STAFF REPORT

RE: **4a) Case No. SD1473A – Kinsley Forest Commercial First Plat**
4b) Case No. 12970-P-28

REQUESTS: **4a)** to approve a final plat on approximately 9.9 acres generally located at southwest corner of NW Englewood Road and Highway 169 to allow creation of six (6) commercial lots and one (1) tract in District B3-2 (Community Business dash 2).
4b) to allow for the amendment of the overall site layout and to change the uses as allowed by the existing development plan.

EXISTING CONDITIONS:

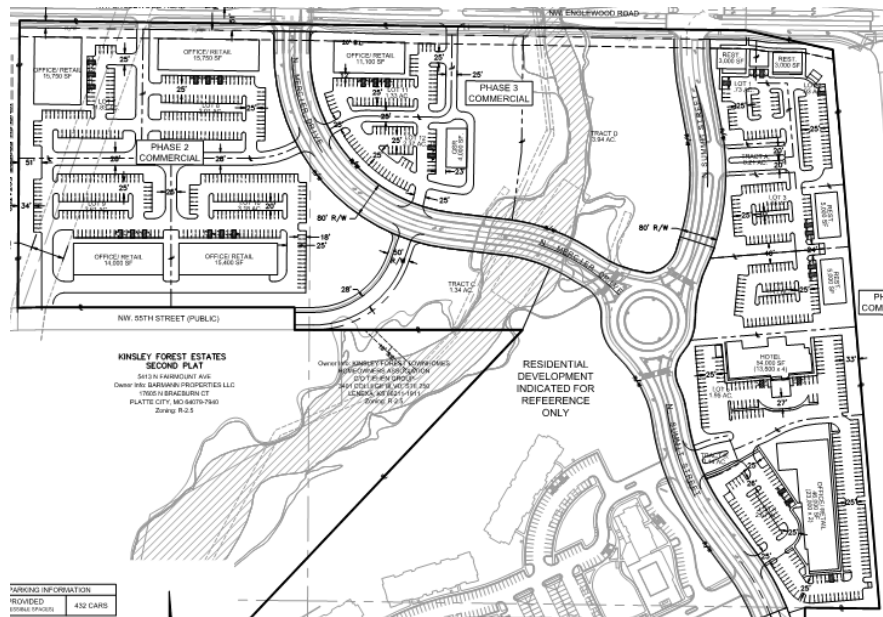
The subject property is a 29 acre undeveloped tract of land located south of NW Englewood Rd and west of Highway 169 within a larger development known as Kinsley Forest. Much of the subject property is forested with steep terrain. Access to the site is proposed off NW Englewood Rd. The applicant is proposing to modify the approved plan on the property expanding the allowed uses from retail and residential to all uses as permitted in district B3. Modifications also include designing the site to comply with the parkway and boulevard standards.
